Comment (#54 P164 L4, #55 P164 L20)

1. TDL#370 D2.3 need to be resolved:
Comment: Figure 145-22 is titled "PSE PI unbalance specification and E2EP2PRunb" This impossible abbreviation...
Response: (Yair): check correct usage of these terms and provide new definition(s).
2. Figure 145-22 need some updates to match with the current text in D2.4.

Figure 145-22—PSE PI unbalance and system end to end pair-to-pair effective resistance unbalance test verification model.

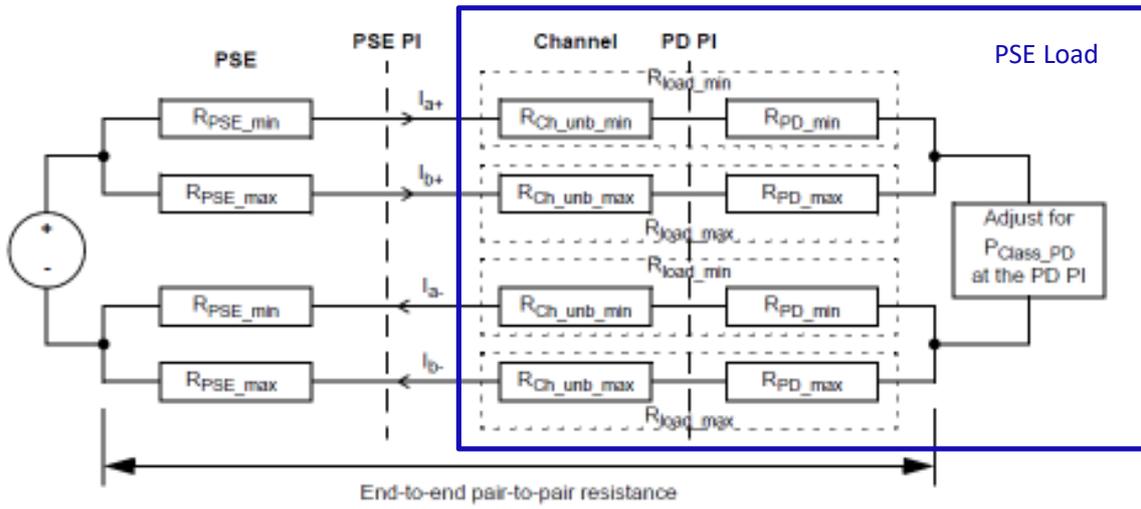
2. *Change the title of Figure 145-22 from:*

3. *Update Figure 145-22 as follows:
(Adding the blue rectangular that shows what is PSE load when PSE is evaluated for unbalance)*

Figure 145-22—PSE PI unbalance specification and system resistance unbalance

To:
